PERRY NUCLEAR POWER PLANT, UNIT NO. 1

AMENDMENT TO FACILITY OPERATING LICENSE

Amendment No. 61
License No. NPF-58

ATTACHMENT TO LICENSE AMENDMENT NO. 61

FIGURE 3.4.1.1-1

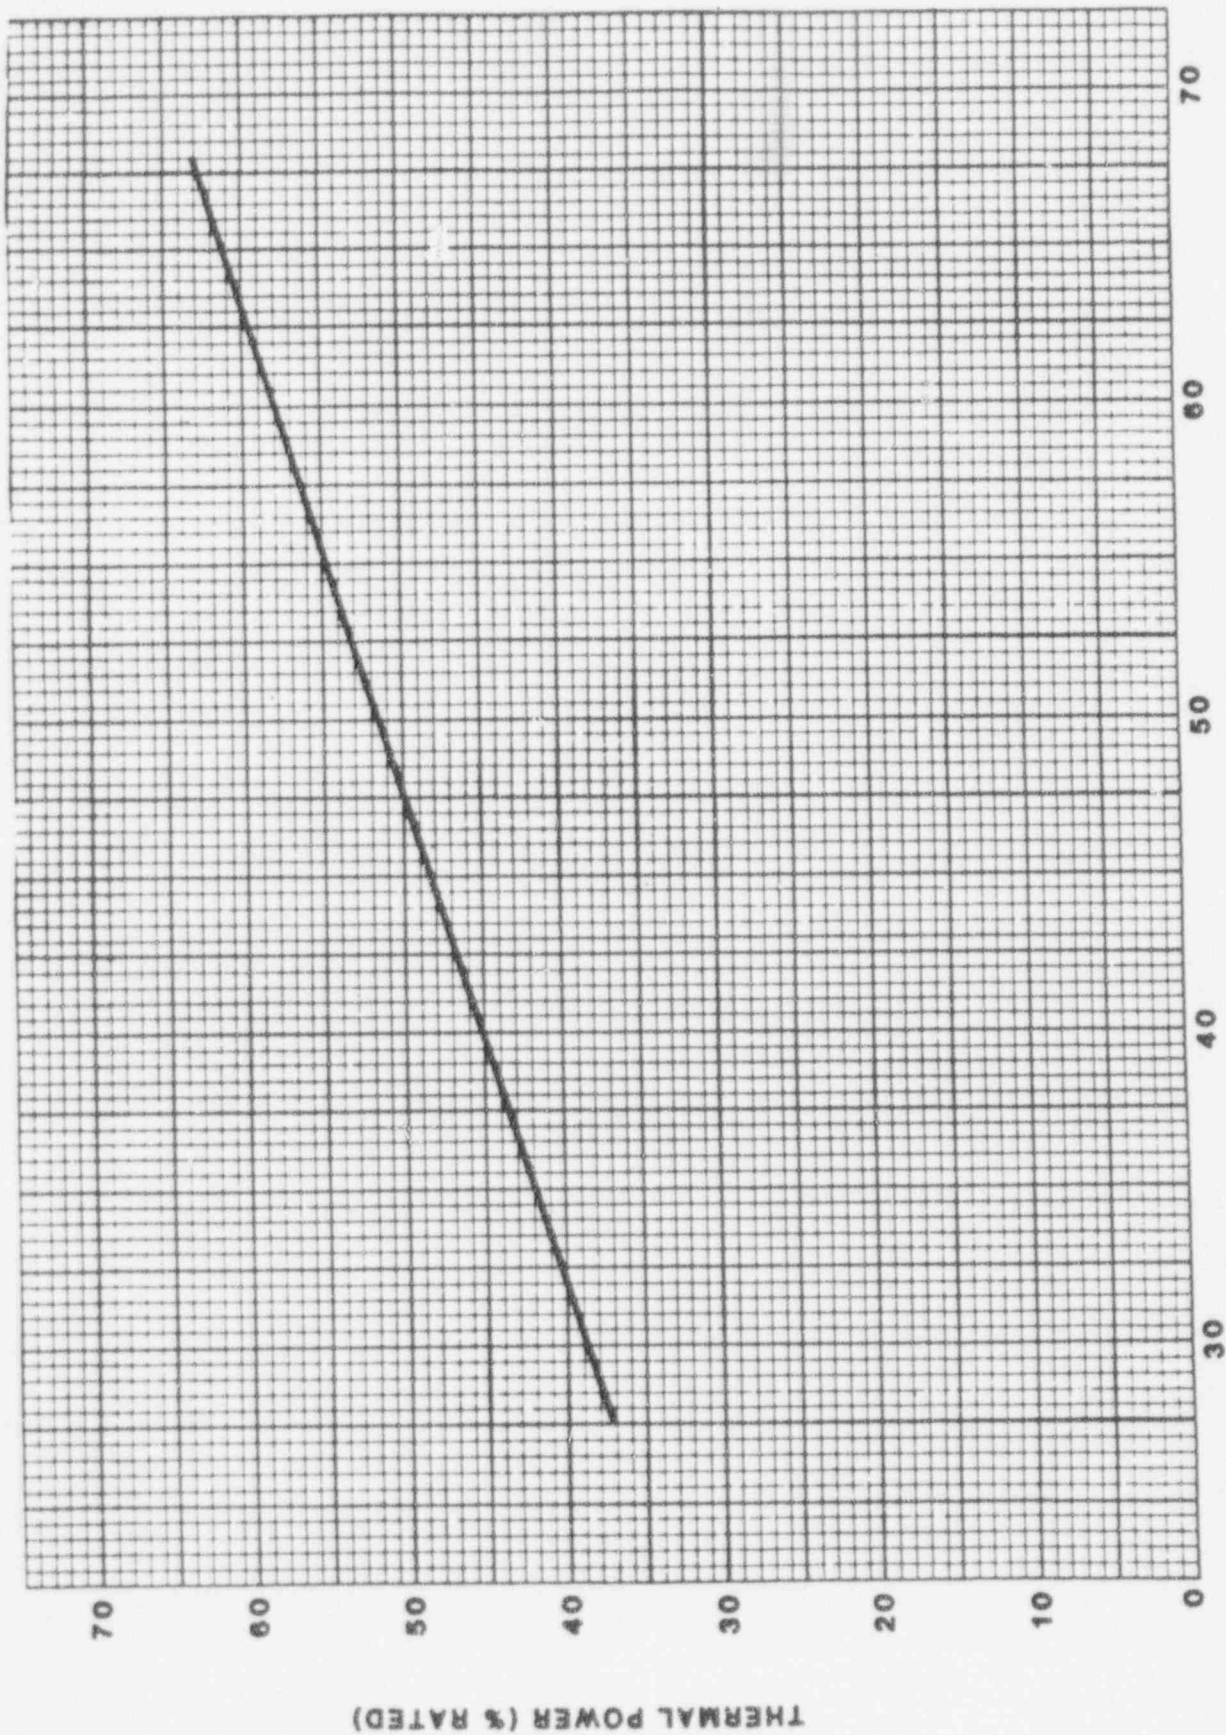
3.4.1.1 The reactor coolant system recirculation loop(s) shall be in operation with the total core flow greater than or equal to 45% of rated core flow, or THERMAL POWER less than or equal to the limit specified in Figure 3.4.1.1-1 and either:

- g. With one or two reactor coolant system recirculation loops in operation, and total core flow less than 45% of rated core flow and THERMAL POWER greater than the limit specified in Figure 3.4.1.1-1:
1. Determine the APRM and LPRM^{##} noise levels (Surveillance 4.4.1.1.2):
 - a) At least once per 8 hours, and
 - b) Within 30 minutes after the completion of a THERMAL POWER increase of at least 5% of RATED THERMAL POWER.
 2. With the APRM or LPRM^{##} neutron flux noise levels greater than three times their established baseline noise levels, immediately initiate corrective action to restore the noise levels to within the required limits within 2 hours by increasing core flow to greater than 45% of rated core flow or by reducing THERMAL POWER to less than or equal to the limit specified in Figure 3.4.1.1-1.
